APPROVED AND ADOPTED

Aspen Hill

Minor Master Plan Amendment

SUBJECT: Approval of December 2014 Planning Board Draft Aspen Hill Minor Master Plan Amendment

Map 7: Proposed Zoning

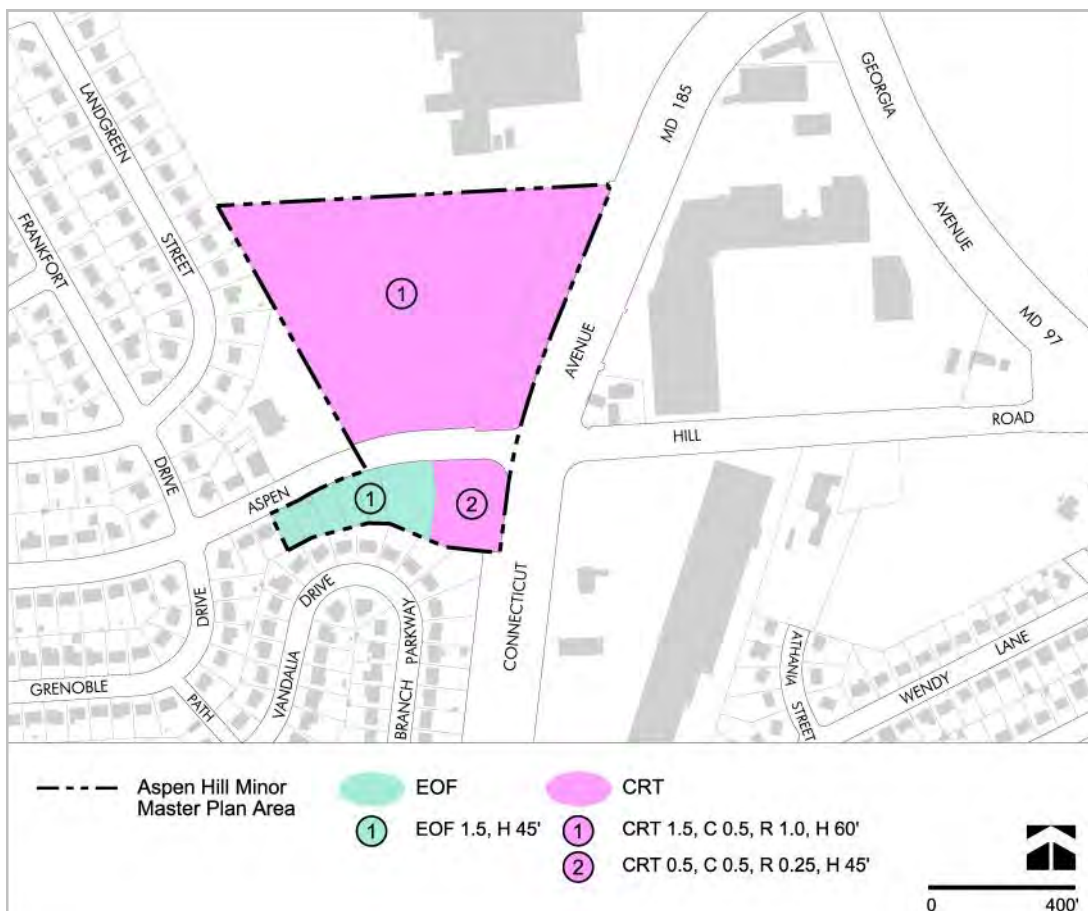
Page 13: Revise Proposed Zoning Map (Map 7) to reflect Council changes.

Figure 1: Properties North of Aspen Hill Rd

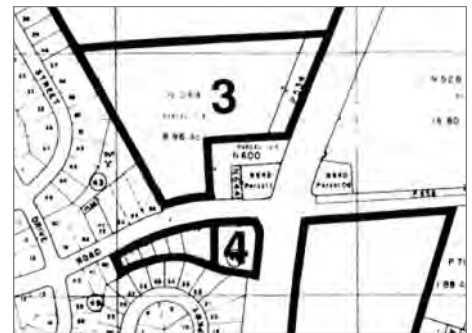
Page 14: Revise the Recommendation heading and bullets as follows:

- Rezone the entire Minor Amendment area north [properties on the northwest corner] of Aspen Hill Road and west of Connecticut Avenue (Figure 1 above, No. [2] 1) from EOF-3.0, H-60, R-90, and CRT-0.75, C-0.75, R-0.25, H-45 to CRT-1.5, C-0.5, R-1.0, H-60.
- [Rezone the remaining properties on the north and northwest portion of the Minor Amendment Area (Figure 1 above, No. 1) from EOF-3.0, H-60 and R-90 to NR-0.5, H-60.]

Figure 3: Design Criteria Diagram

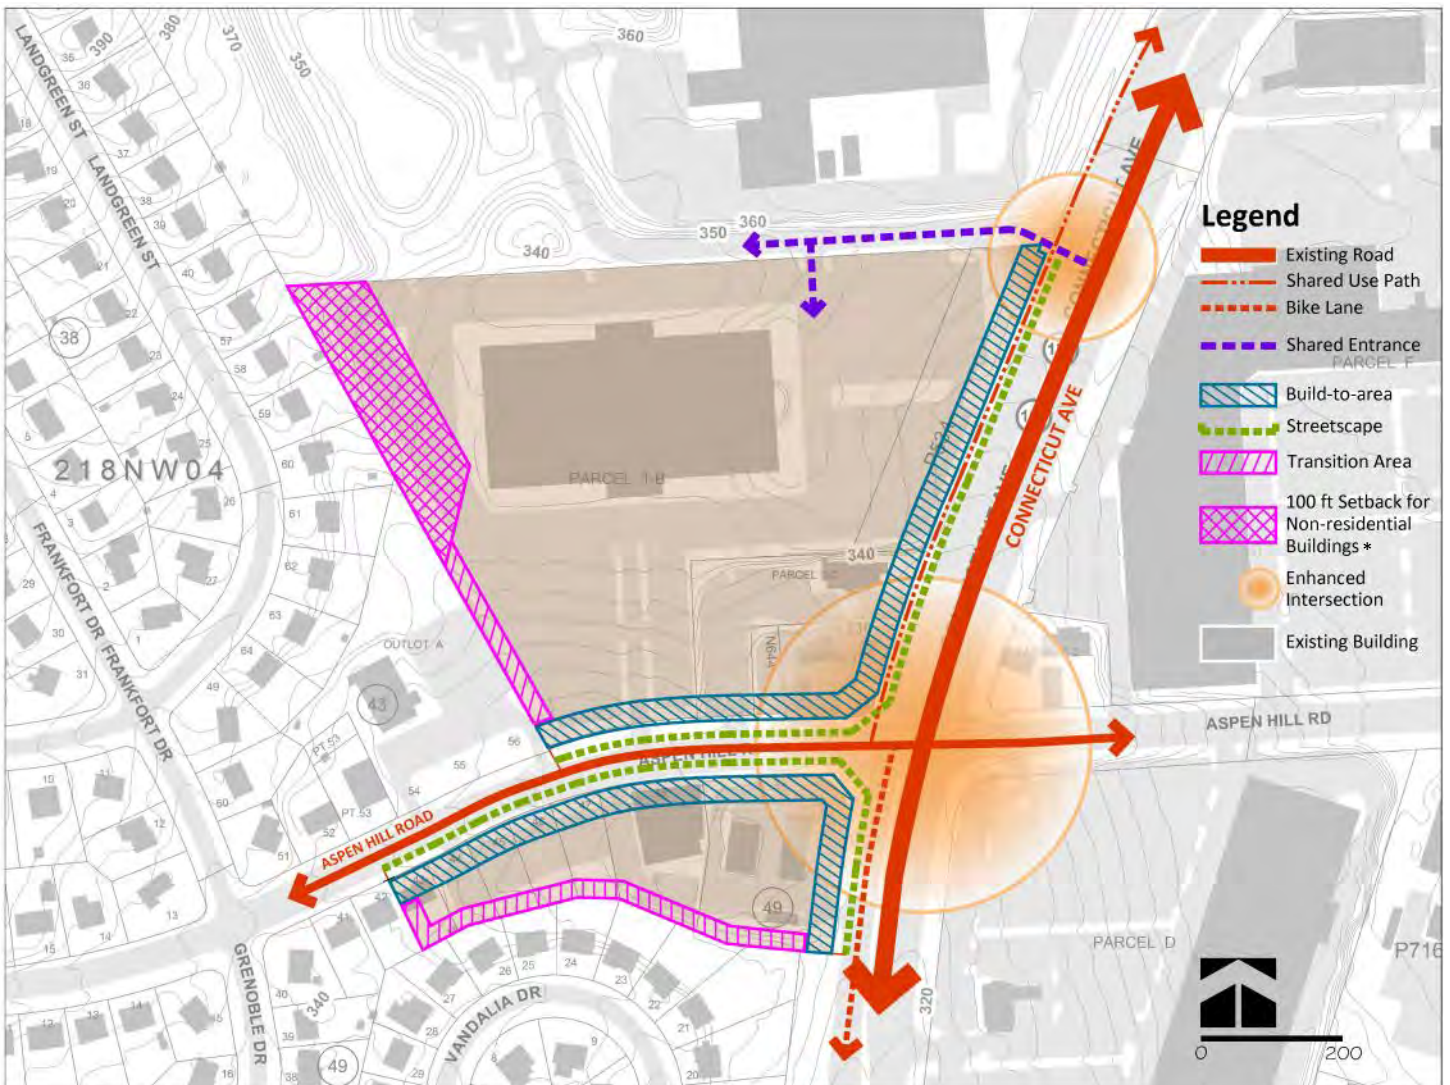
Page 17: Revise Figure 3: Design Criteria Diagram to illustrate the transition area along the entirety of the western edge of the Vitro/BAE property line on the north side of Aspen Hill Road and add footnote indicating that the length of the 100 foot setback for non-residential buildings depends on the location of adjacent detached homes.
